BULLETIN T-64-41

SUBJECT: TRIUMPH TR-4 WINDOW
WINDER REGULATOR

DATE: DECEMBER 10, 1964

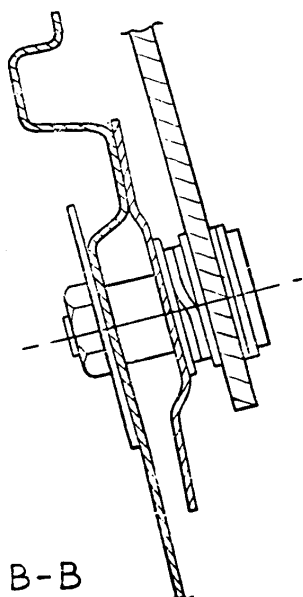
3. Adjust bottom brackets and crimp the tie rod to ensure that the channels are parallel (illustration C).
4. Remove regulator pivot pin nut and delete spring washer under head of nut. Add washer WP0119 1/2"x 7/8" x .050" behind head of pivot bolt and additional washer WP0160 5/16" x 1 5/8" x 16 S.W.G. behind head of nut (illustration B-B).

A-A

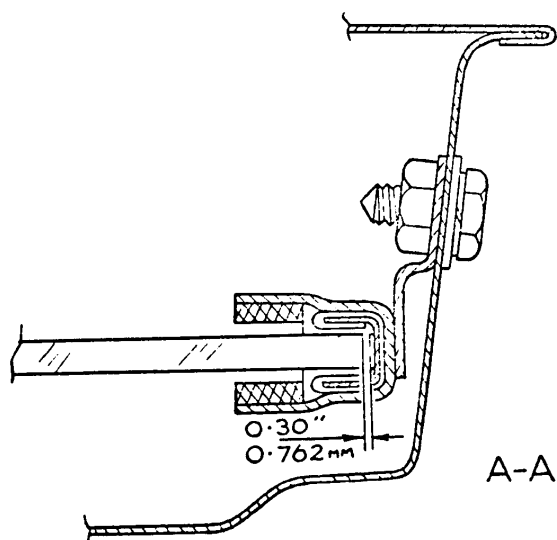
1. Remove trim panel.
2. Raise window and check the clearance of the glass fore and aft in the top of the rear channel. The recommended clearance is .030" which should be maintained for the whole length of the channel. Excess clearance will allow tilting and the jamming of the glass and insufficient clearance will produce stiff operation. Clearance can be obtained by the use of packing washers between the inner door panel and top channel bracket (see illustration A-A).
